SUBJECT: City of Wilsonville Plan Amendment  
DLCD File Number 001-10

**AN ORDINANCE OF THE CITY OF WILSONVILLE AMENDING THE VILLEBOIS VILLAGE MASTER PLAN TO RELOCATE THE PLANNED ELEMENTARY SCHOOL FROM THE NORTH SPECIFIC AREA PLAN (SAP) TO THE EAST SPECIFIC AREA PLAN (SAP) WITH ASSOCIATED MAP AND TEXT MODIFICATIONS.**

Attachment 2: Planning Commission Recommended *Proposed Legislative  
Amendment Villebois Village Master Plan (case file no. LP10-0001)*

## PROPOSED LEGISLATIVE AMENDMENT VILLEBOIS VILLAGE MASTER PLAN (City File No. LP10-0001)

**Exhibit 1**  
**Figure 1: Land Use Plan**

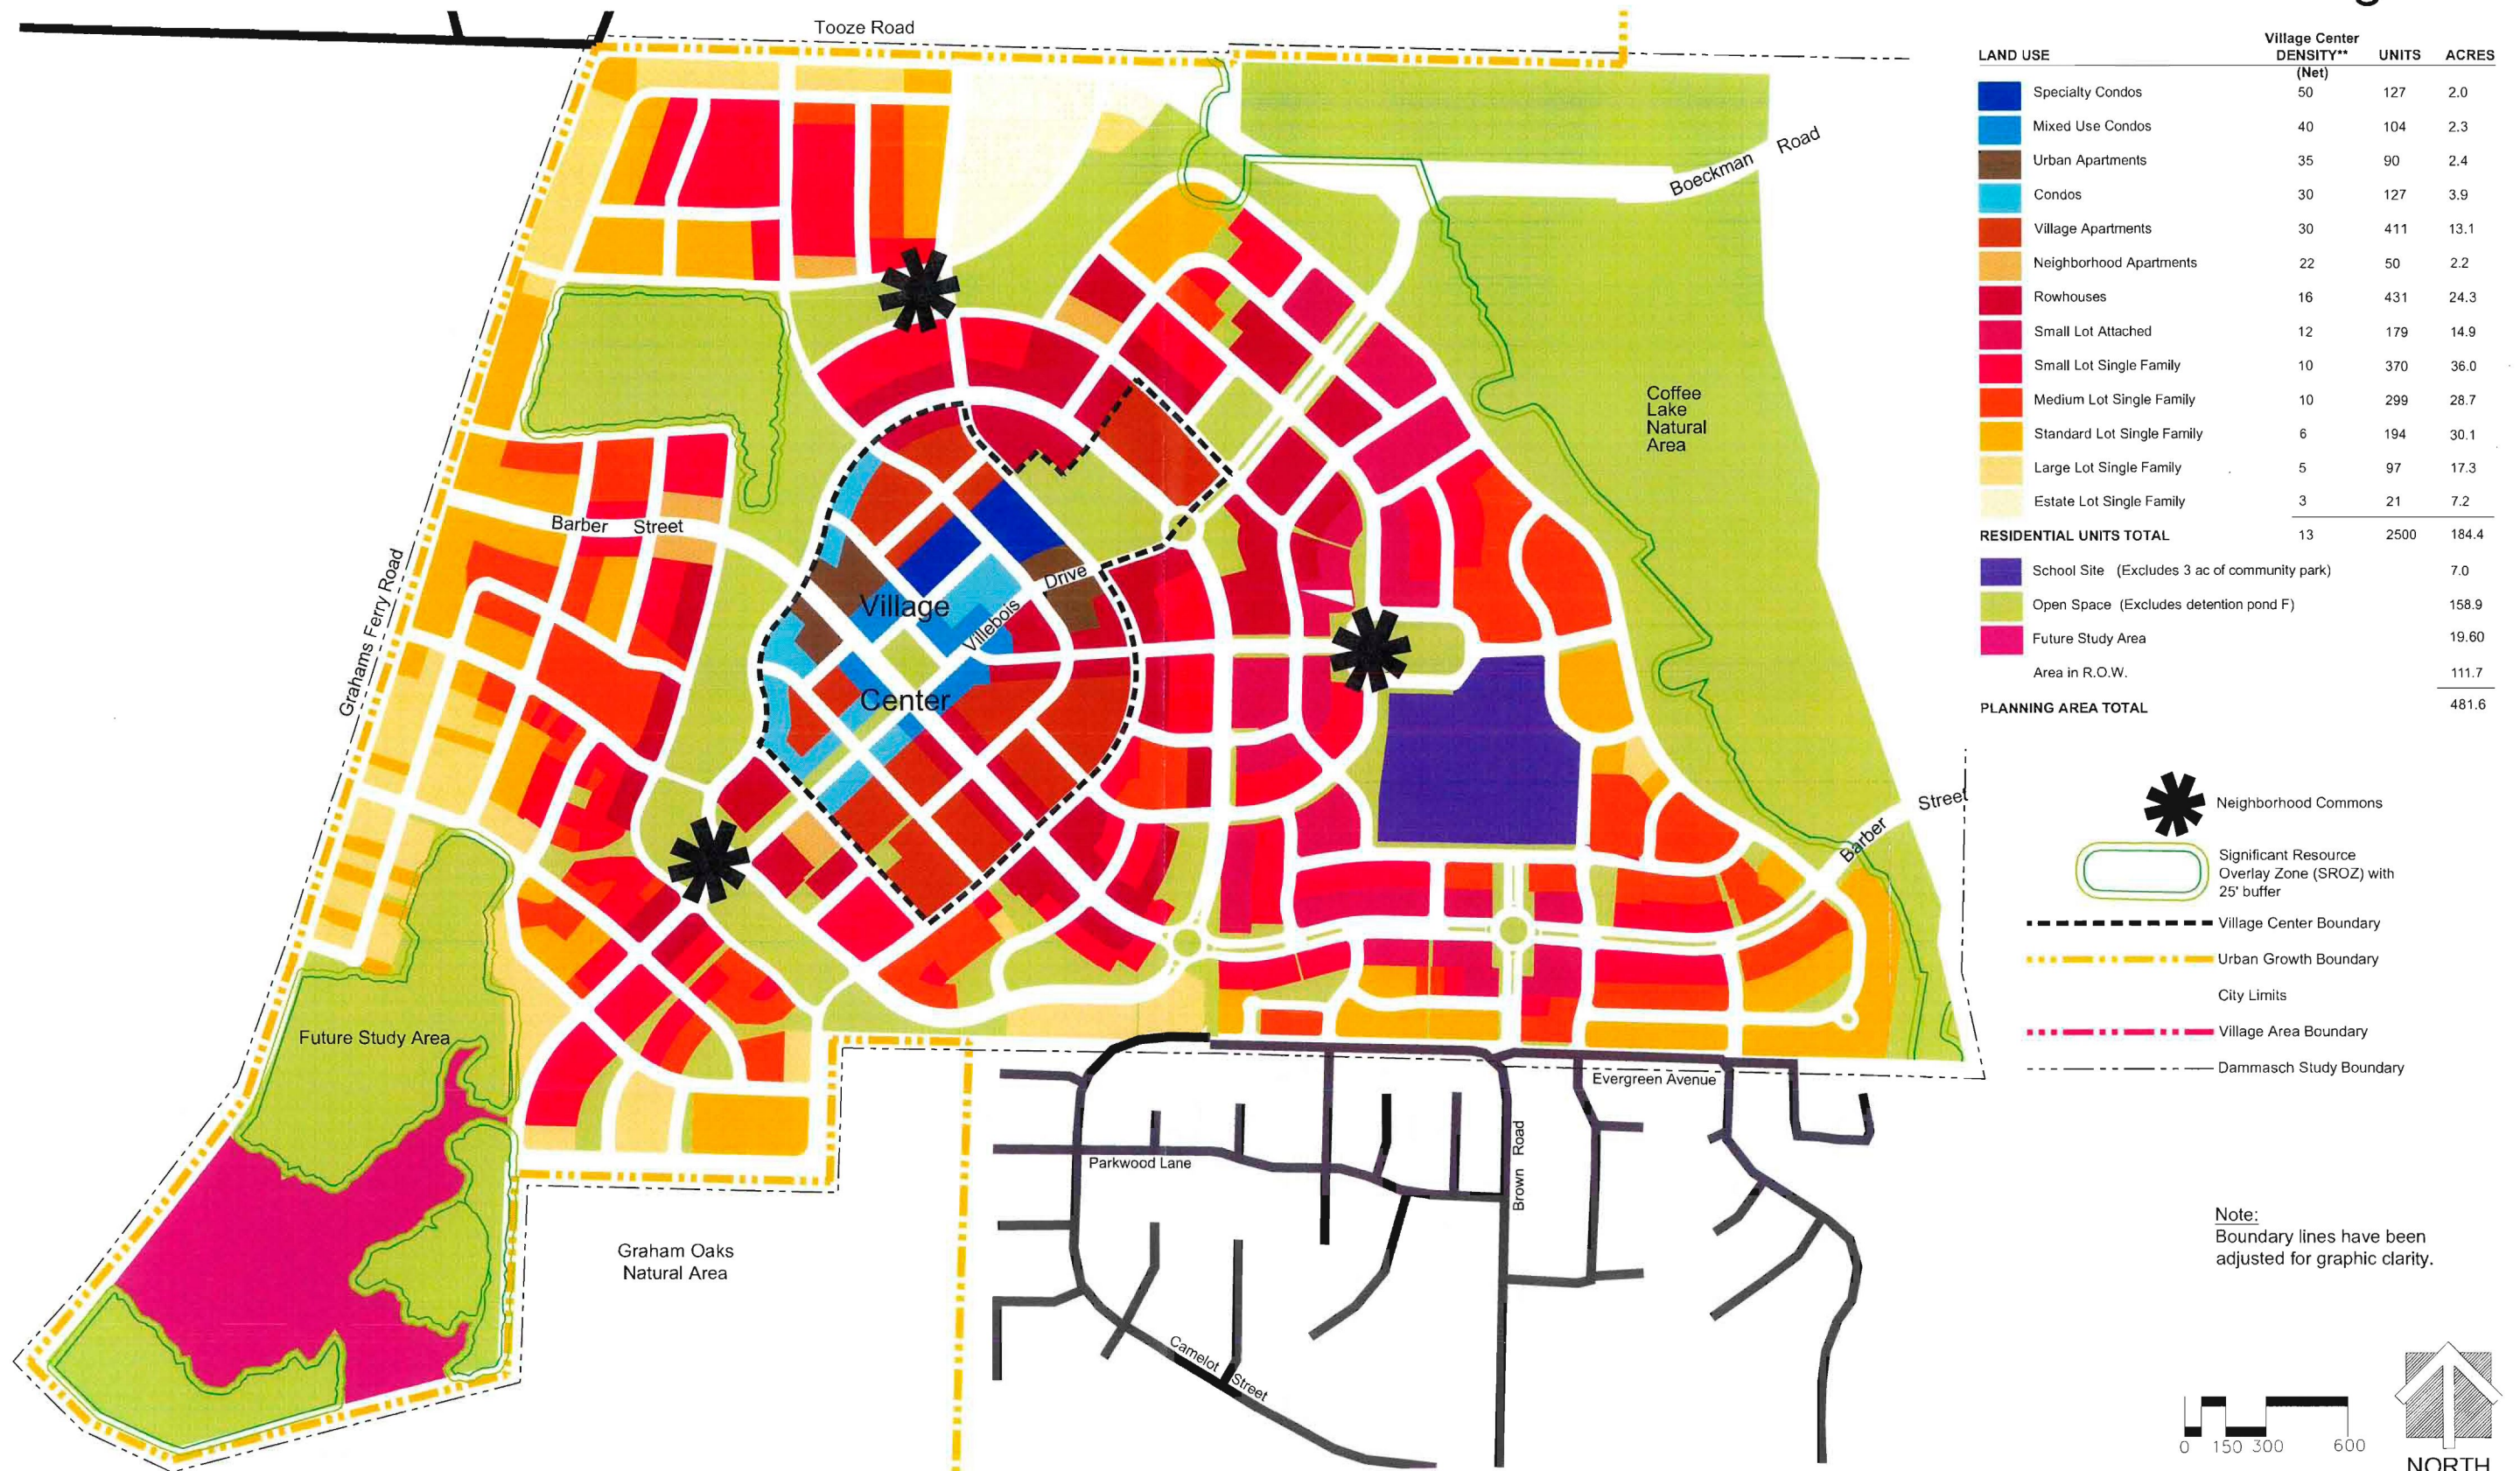
- **Figure 1 - Land Use Plan** map has been modified to delete the residential land uses in the east and have been replaced by the primary school site. The school site will contain 3-acres of community recreation in the form of outdoor covered basketball, playgrounds, and sports fields. The recreational programming of the school site is not proposed to be changed. The land uses in the north have returned to the originally approved master plan housing types and include: small lot single family; medium lot single family; standard lot single family; large lot single family and neighborhood apartments.

**Exhibit 2**  
**Figure 3: Conceptual Specific Area  
Plan Boundaries**

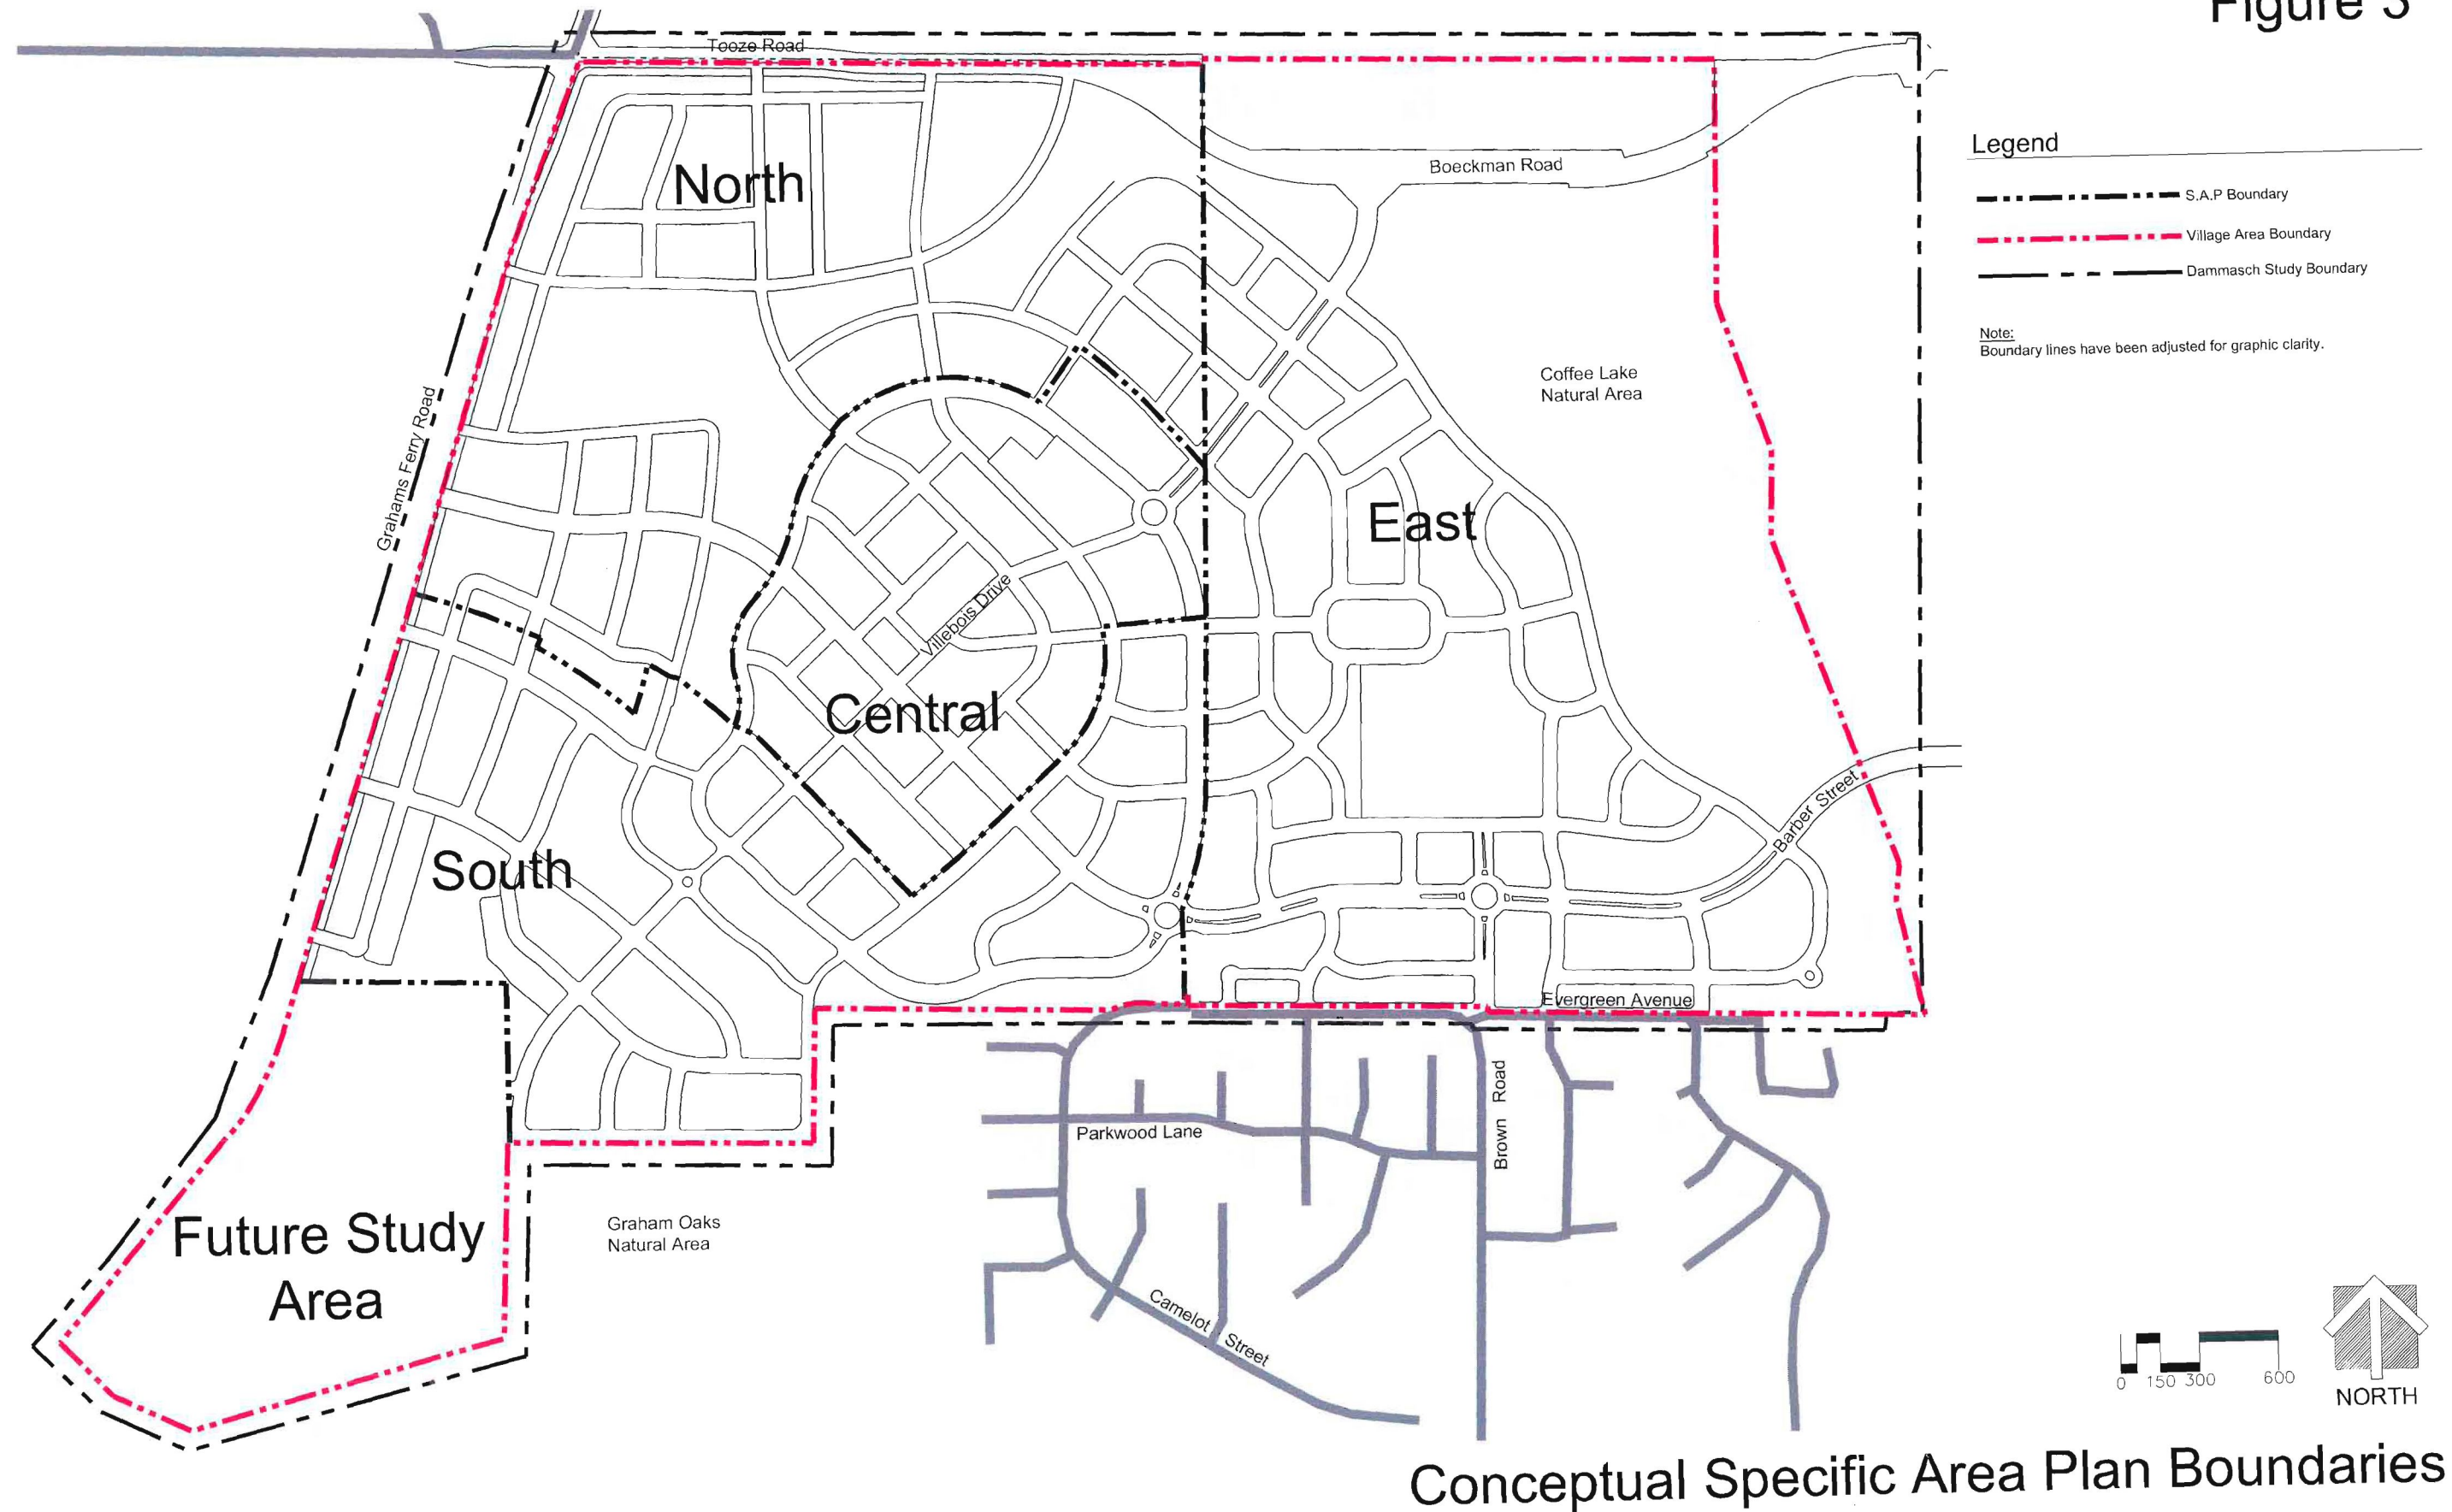
- **Figure 3 - Conceptual Specific Area Plan Boundaries** has been modified to depict a new street grid reflecting the new school site in the east and the reprogramming of residential uses in the north. No other changes are proposed.

**Exhibit 3**  
**Figure 4: Conceptual Sequence of Development**

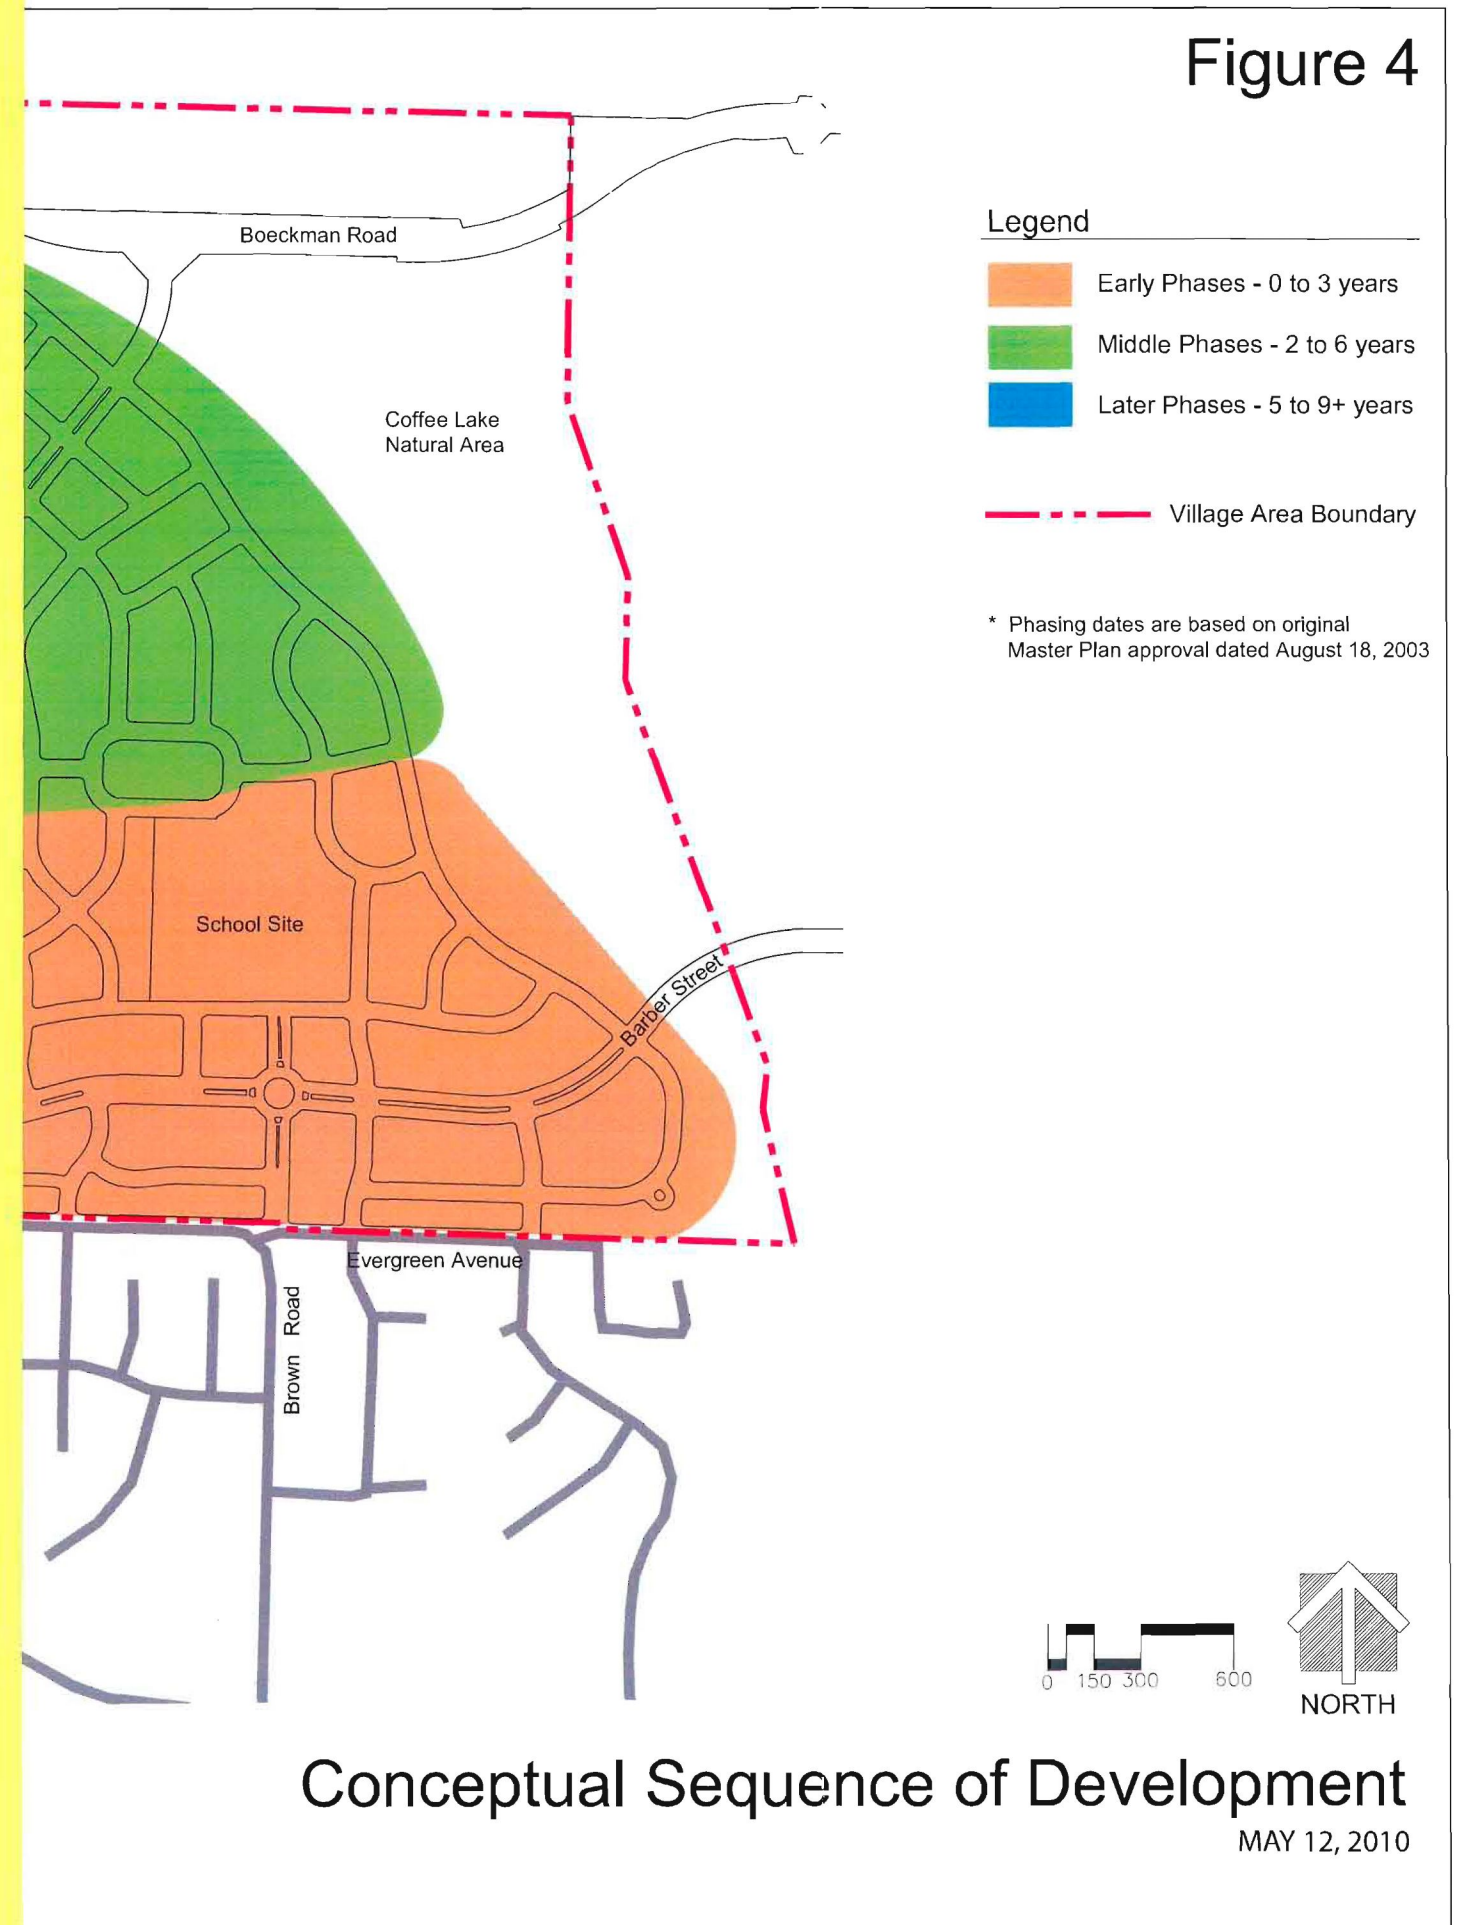
- **Figure 4 – Conceptual Sequence of Development** has been modified to depict a new street grid reflecting the new school site in the east and the reprogramming of residential uses in the north. No other changes are proposed.
